SACRAMENTO MUNICIPAL UTILITY DISTRICT
The Power To Do More.SM

Docket No. 50-312
Rancho Seco Nuclear Generating Station
License No. DPR-54

RESPONSE TO NRC REQUEST FOR ADDITIONAL INFORMATION

Response to RAIs Dated October 24, 2006

Hole Size 5-1/2", 6-1/4"Hole No. DH-23Site RANCHO SECO

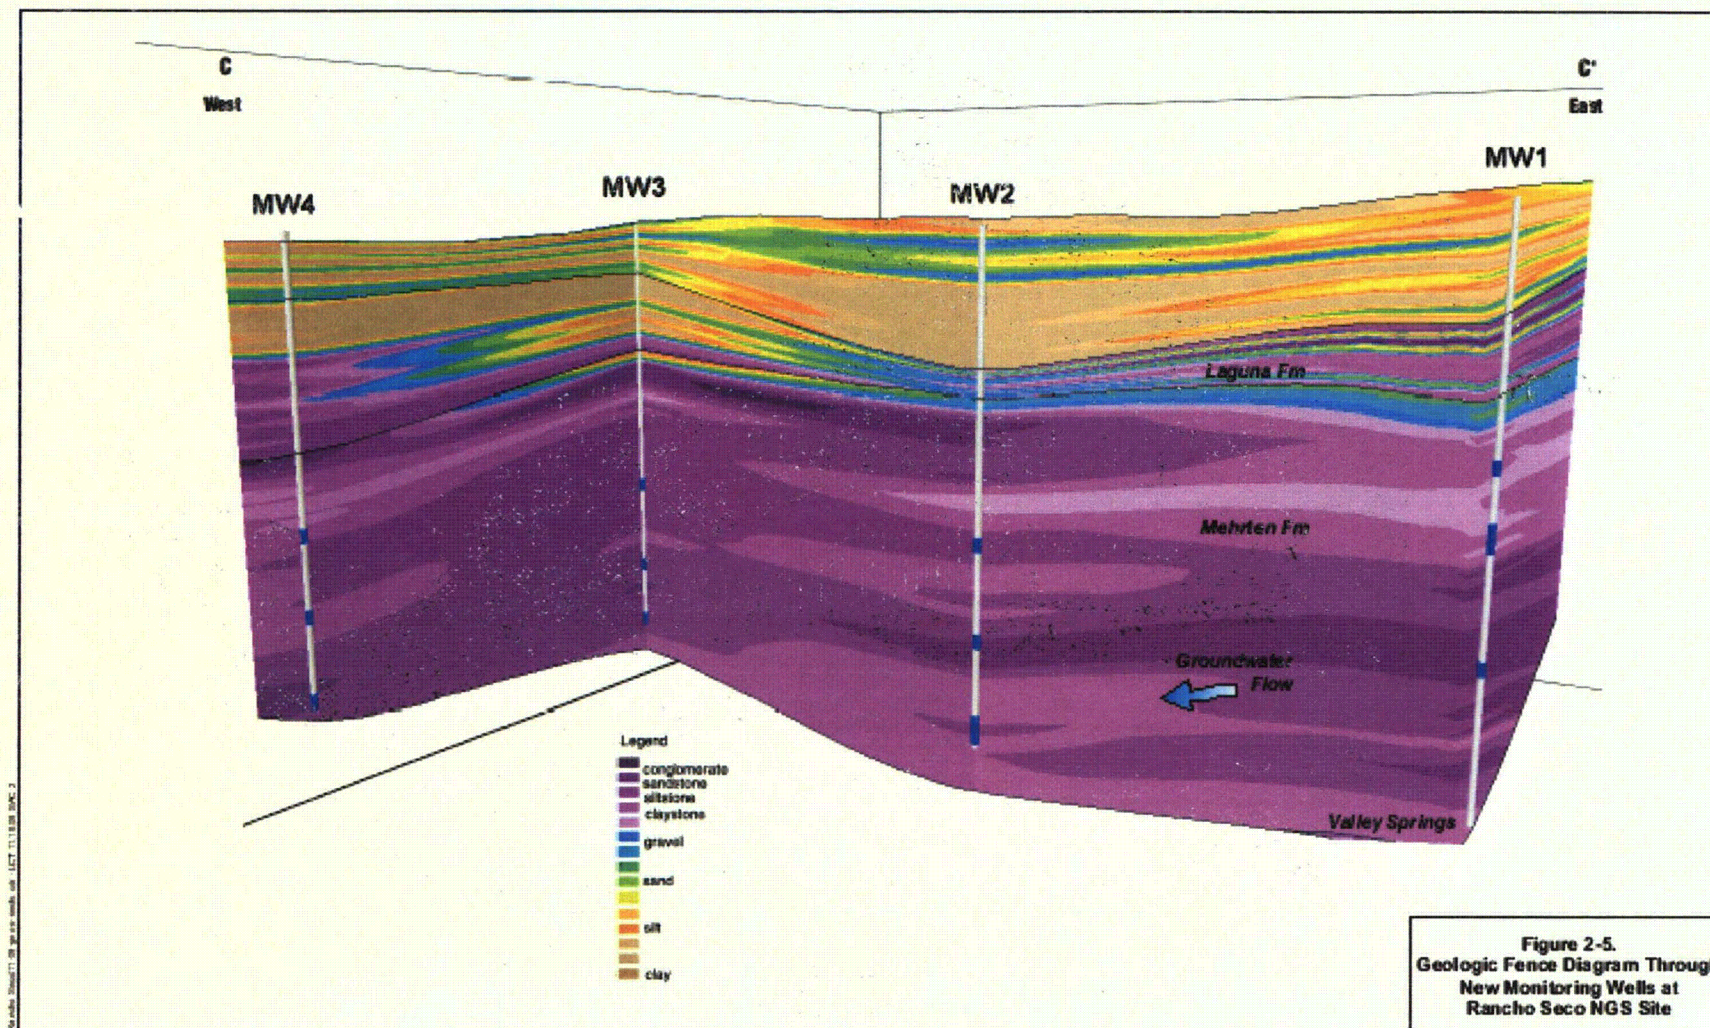
For soil boring DH-23, please provide a boring log including geologic formation, their depths and the total depth of the soil boring DH-23.

The "Rancho Seco Nuclear Generating Station, Unit No. 1, Updated Final Safety Analysis Report" will be added as a reference for LTP Section 2.2.1.1. The boring log for DH-23 is provided as Attachment 1 to this RAI response.

FIGURE 4
FENCE DIAGRAM—SOILS BORINGS

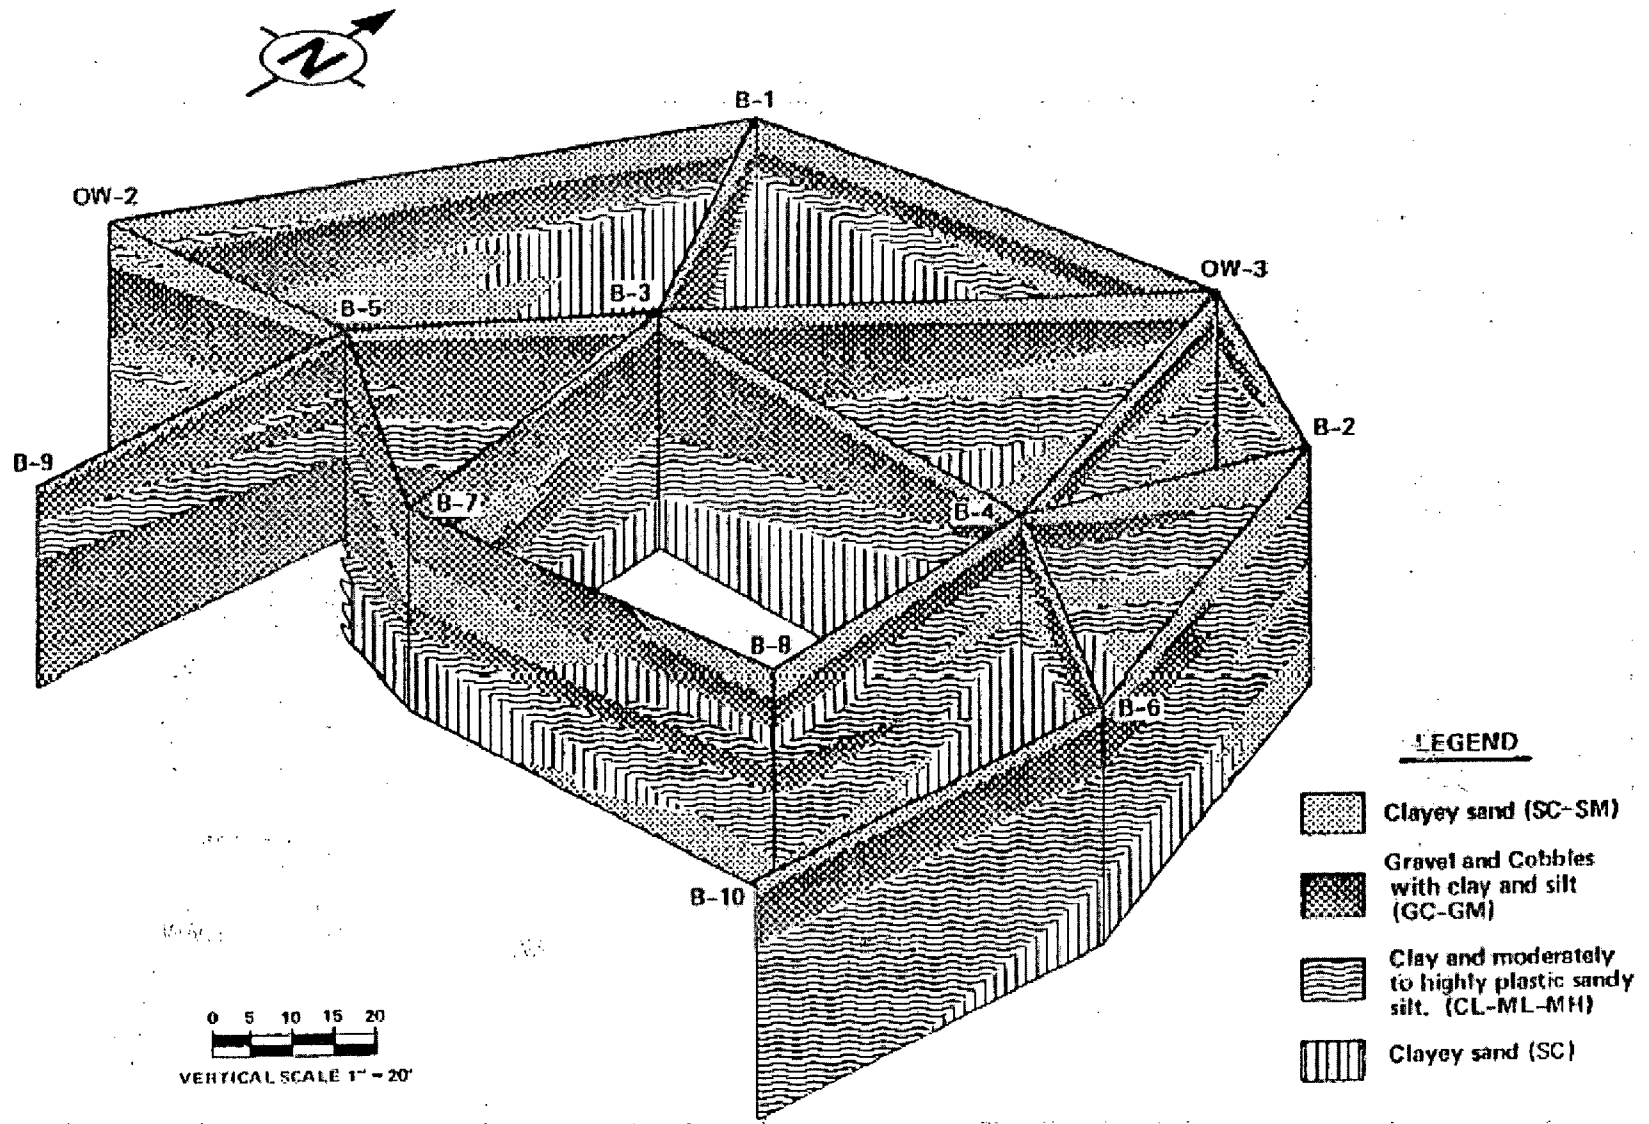
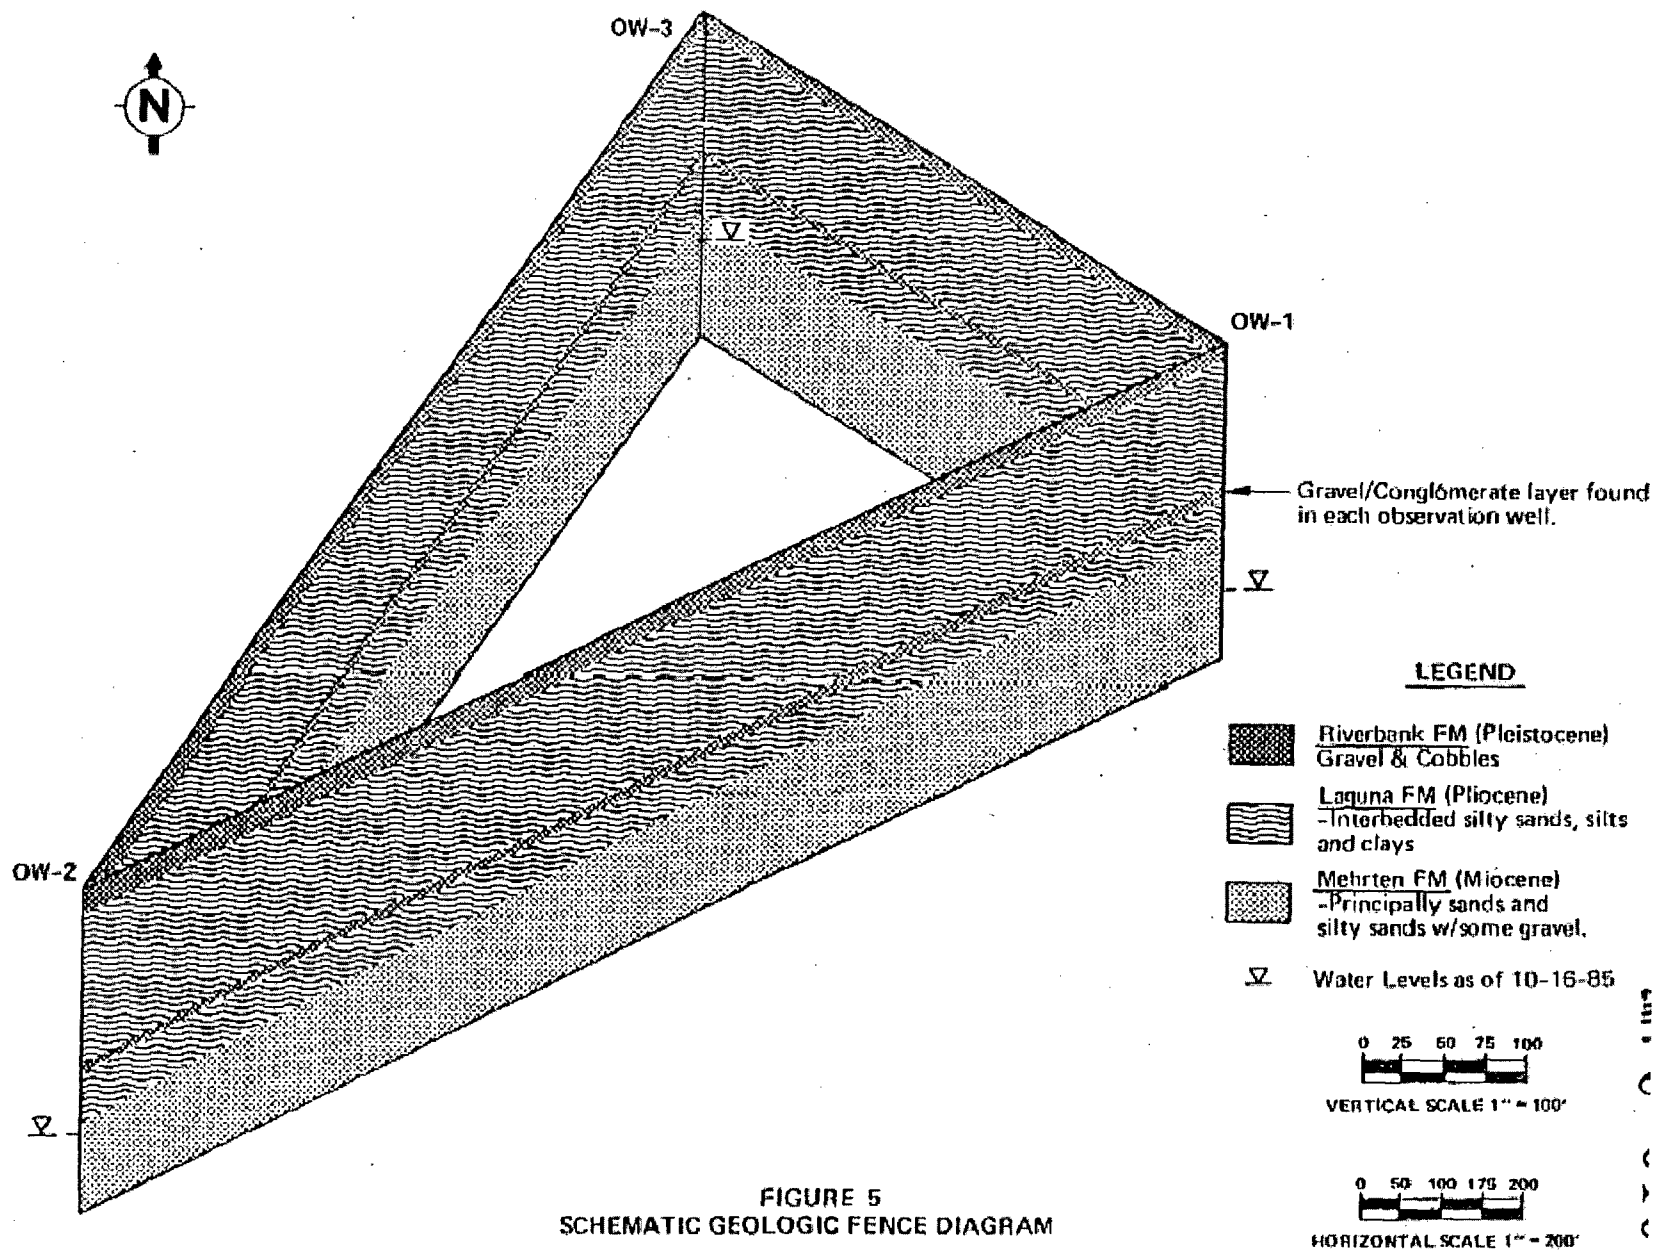
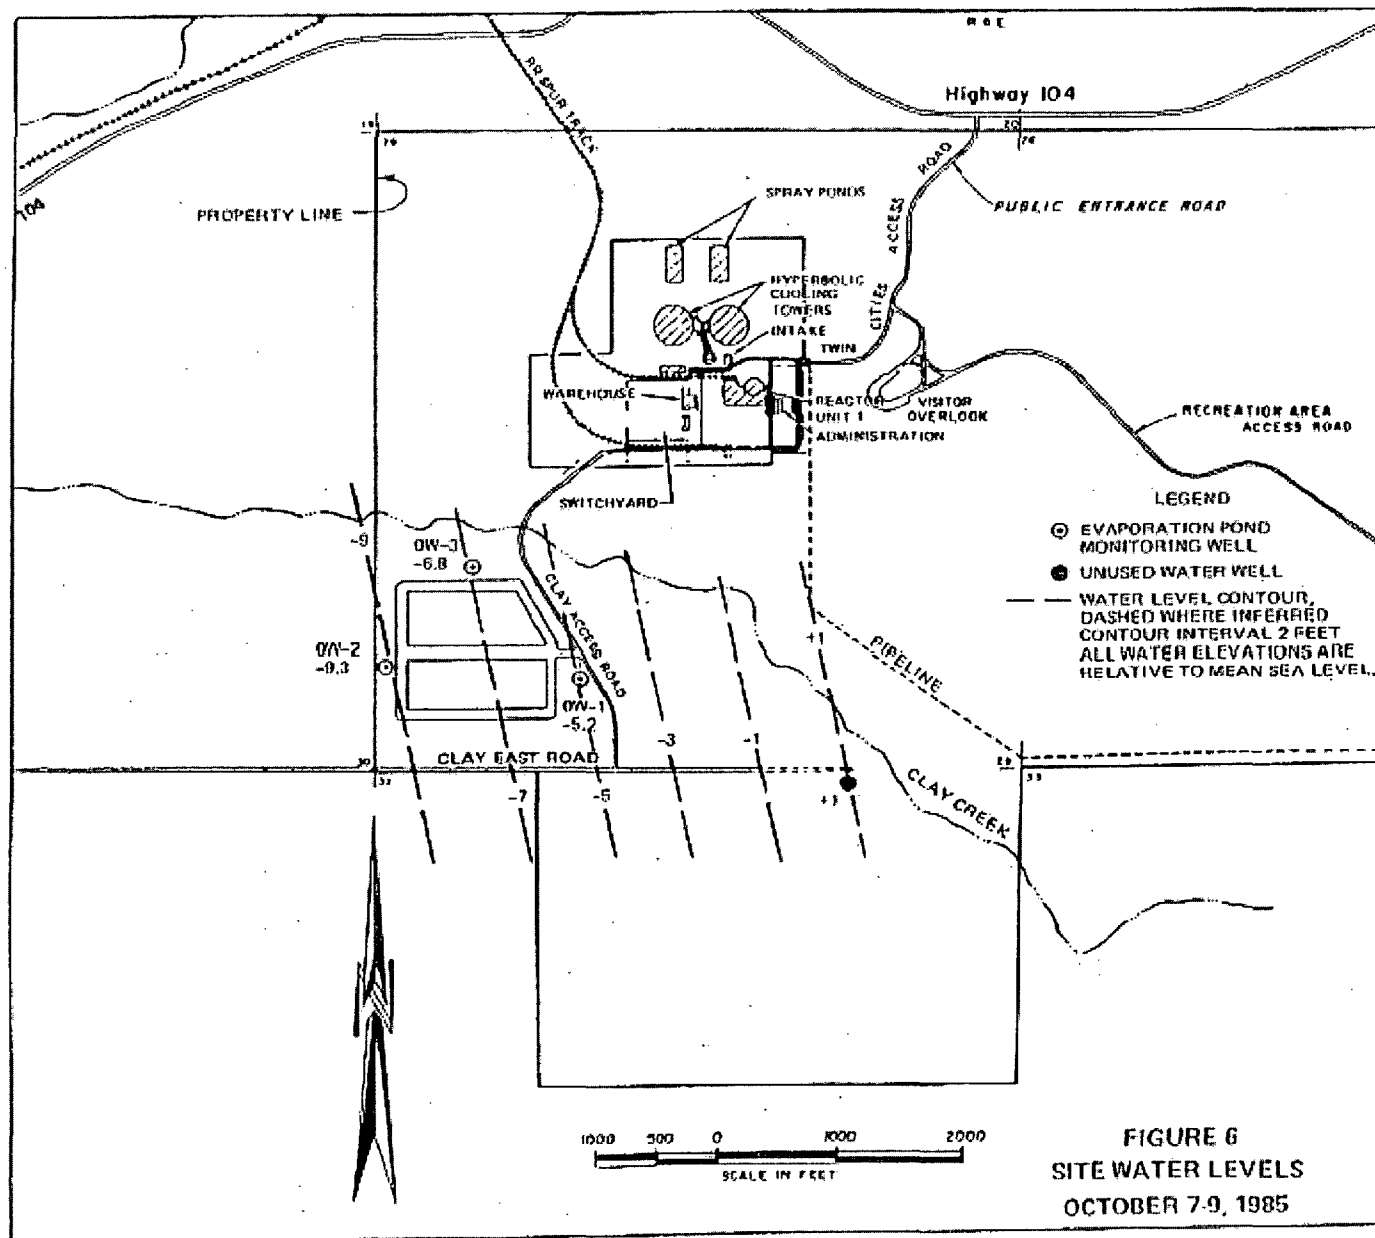
In addition to describing the stratigraphy of the site, please provide geologic cross-sections and fence diagrams to better illustrate the subsurface geology and the geohydrologic parameters of the site.

Also, please provide geologic cross-section(s) indicating the subsurface geology for borings MW2, MW3, MW4, OW2 and OW3 (Page 2-28).

The Hydrogeological Characterization Report will be revised to include a new figure (Figure 2-5) to provide a fence diagram connecting the new monitoring wells, MW1 – MW4. This new figure is included in Attachment 2 to this RAI response.

Fence diagrams for OW2 and OW3 are provided in Figure 5 of the Geotechnical (included in Attachment 2 to this RAI response) Investigation for Proposed Evaporation Ponds report addressed in the response to RAI No. 37 above.
